V2500-A1/A5/D5 SERIES PROPULSION SYSTEMS SERVICE BULLETIN

This document transmits the Revision 1 of Service Bulletin V2500-ENG-72-0589.

ENGINE – HP COMPRESSOR DISCS (STAGES 3–8) – RE-INTRODUCTION OF DAMPER WIRES OF PRE
SERVICE BULLETIN ENG-72-0472 STANDARD

HP Compressor Stage 6 Damper Wire Family Tree

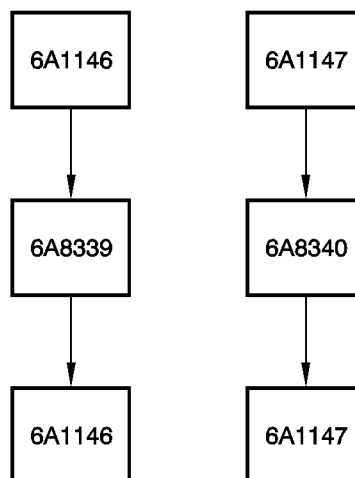
V2500-ENG-72-0589

Engine – HP Compressor Discs (Stages 3–8) – Re-Introduction of Revised Damper Wires of Pre Service Bulletin ENG-72-0472 Standard

HP Compressor Stage 7 Damper Wire Family Tree

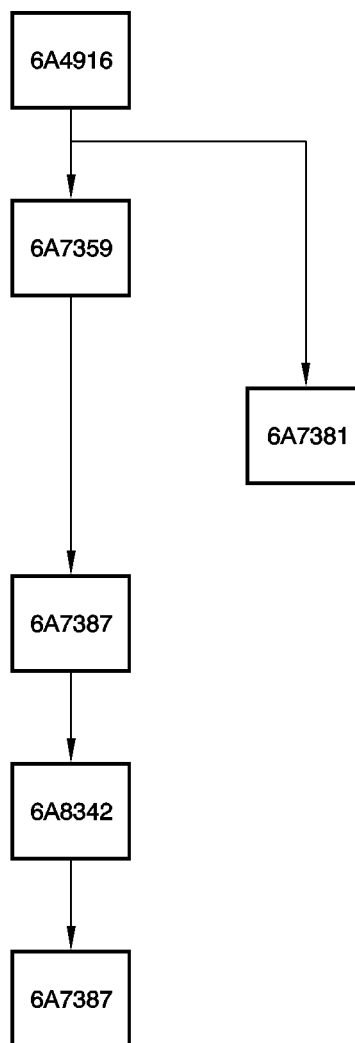
V2500-ENG-72-0589

Engine – HP Compressor Discs (Stages 3–8) – Re-Introduction of Revised Damper Wires of Pre Service Bulletin ENG-72-0472 Standard

HP Compressor Stage 8 Damper Wire Family Tree

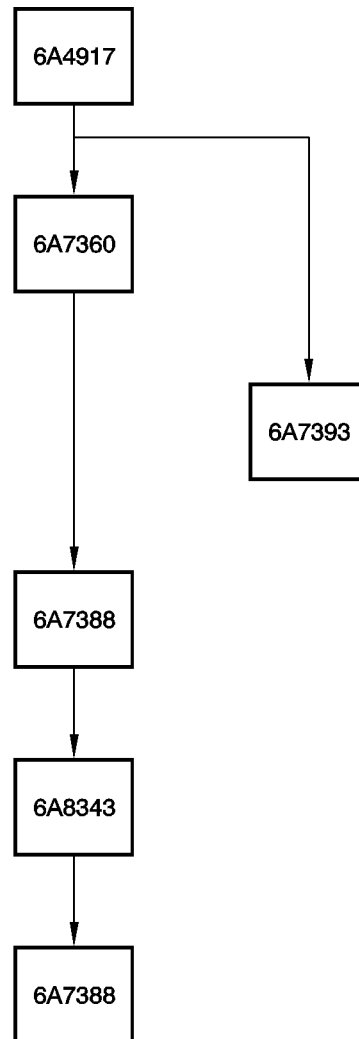
V2500-ENG-72-0589

Engine – HP Compressor Discs (Stages 3–8) – Re-Introduction of Damper Wires of Pre Service Bulletin ENG-72-0472 Standard
